RE: Swens Pad Interim Design, Canyon Fuel Company, LLC, Skyline Mine, C/007/005 Task ID 5828

**Title:** Swens Pad Interim Design Task 5828

**Swens Canyon Ventilation Shaft Pad**

Skyline Mine  
Swens Canyon Shaft  
Interim Facility Layout

DATE: JAN, 2016  
SCALE: 1" = 60'  
DWG. NO.: 3.2.4-4A  
SHEET 1 of 11/29/18

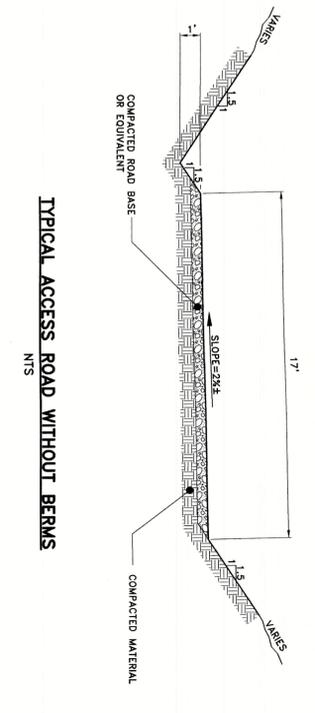
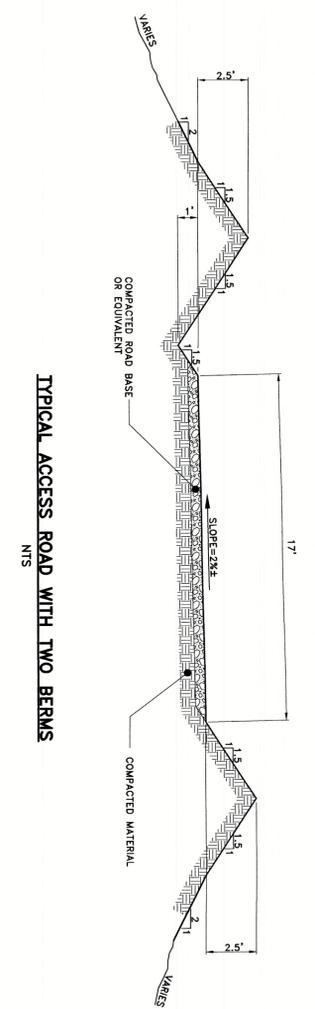
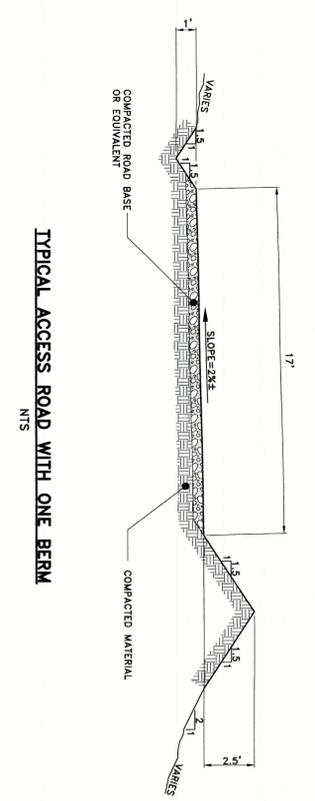
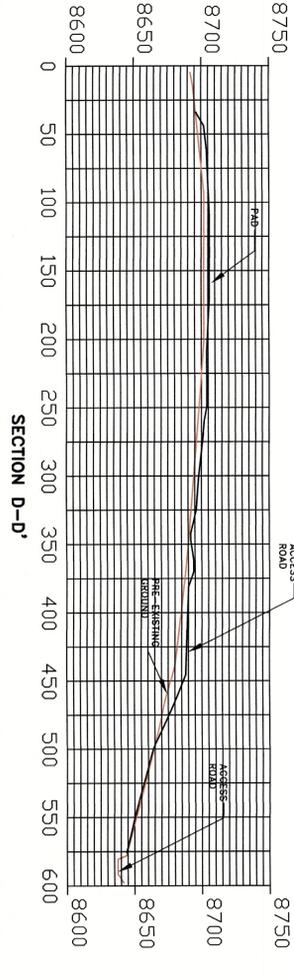
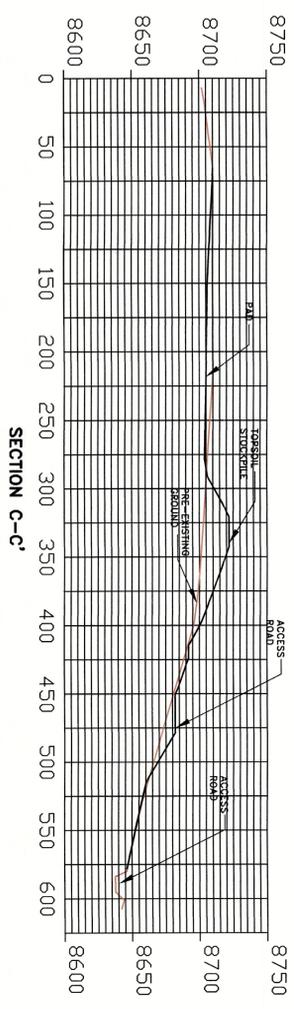
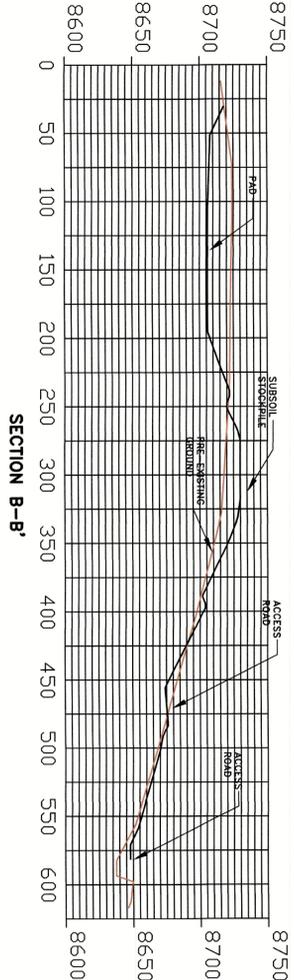
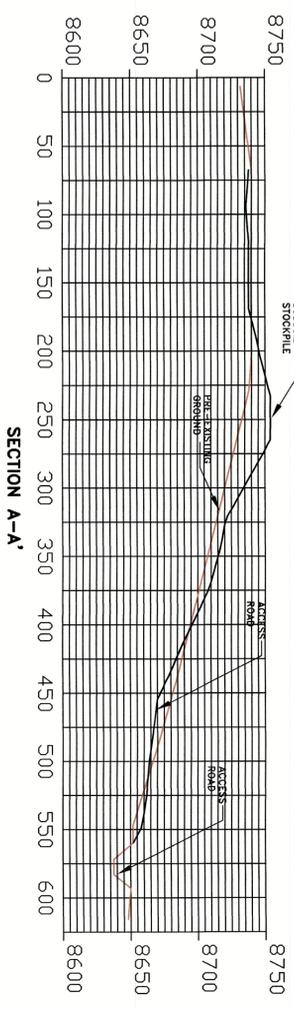
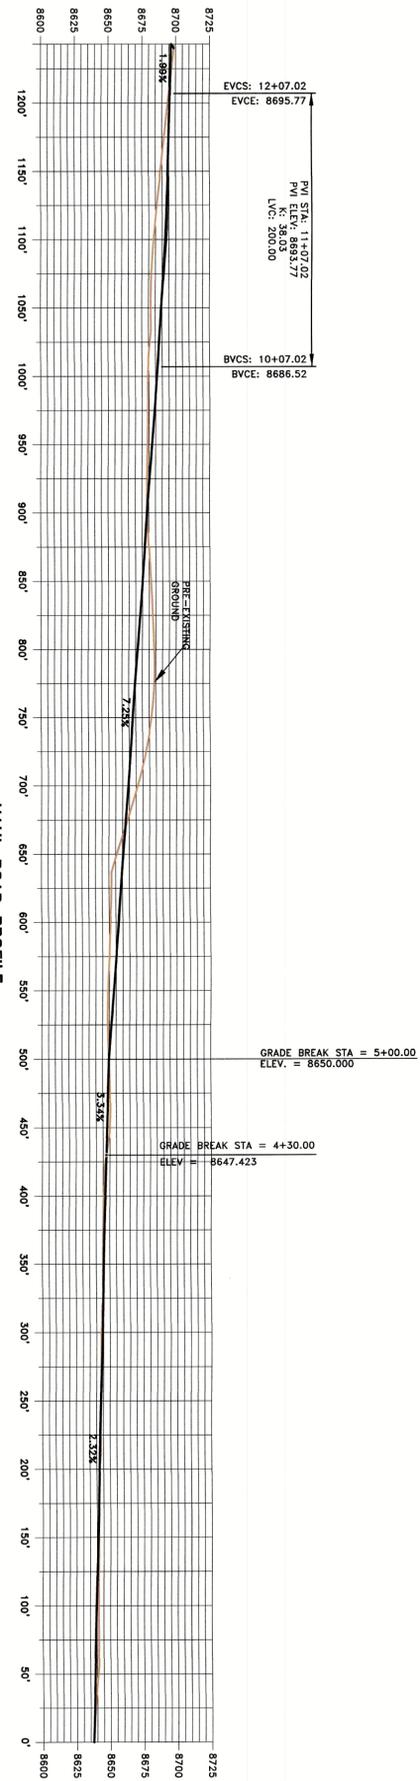
| DATE    | No. | REVISIONS   |
|---------|-----|---|
| 11/7/18 | 2   | Removal of Pond and proposed location of added structures |
